**From:** Crowder, David  
**Sent:** Thursday, August 20, 2015 9:05 PM  
**To:** Lytle, Andy; Light, Cheryl  
**Cc:** Honas, Kris; Knopp, Bryan; Mark Schlagenhauf - DNR; Penny Garrison - DNR; Barbara Westerdale - DNR; Mallery, Josh; Diana Burn - DNR; James Precup - DNR  
**Subject:** RE: Open Hole Sidetrack Approval Request - Adamson 37C-28HZ

**From:** Crowder, David [mailto:[David.Crowder@anadarko.com](mailto:David.Crowder@anadarko.com)]  
**Sent:** Thursday, August 20, 2015 5:44 PM  
**To:** Diana Burn - DNR; [james.precup@state.co.us](mailto:james.precup@state.co.us)  
**Cc:** Honas, Kris; Knopp, Bryan; Lytle, Andy  
**Subject:** Open Hole Sidetrack Approval Request - Adamson 37C-28HZ  
**Importance:** High

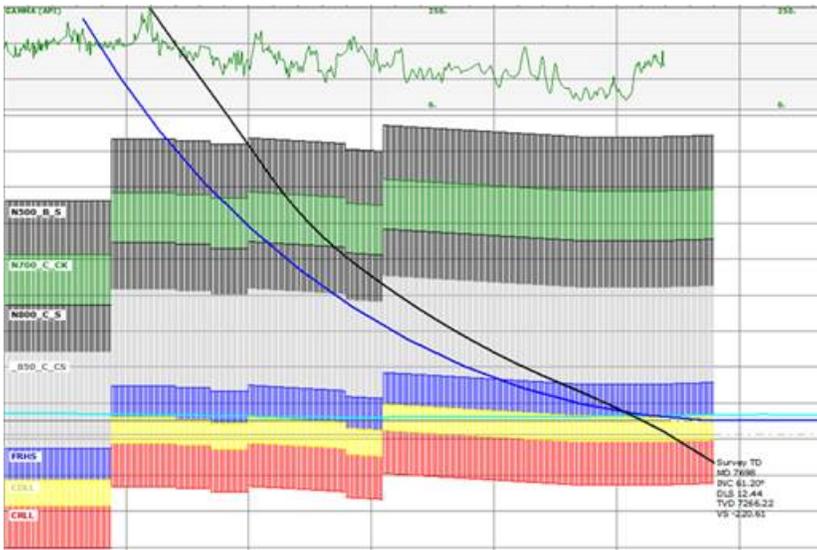
I'm not sure exactly what is being asked for – I have to assume it is an openhole sidetrack, no plugback since there isn't an explicit statement. Please flesh out the details for the proposed plan to approve.

- [A suspected MWD malfunction caused us to deviate from the line while drilling the curve section. The directional driller initiated a slide at 7556' MD to build inclination, and the assembly did the opposite by dropping downwards. This put us in the Carlile formation. See correlation below \(black curve\):](#)

Diana and I spoke via phone, and she is okay with the sidetrack plan.

An open hole sidetrack will be initiated at 7,365' MD. The operation will begin by troughing the existing wellbore, and then time drilling with a controlled slide. The sidetrack well plan has us low siding to the right of the existing wellbore until we gain approx 1.5' of separation. At that time we will roll the assembly back and track towards the original well plan.
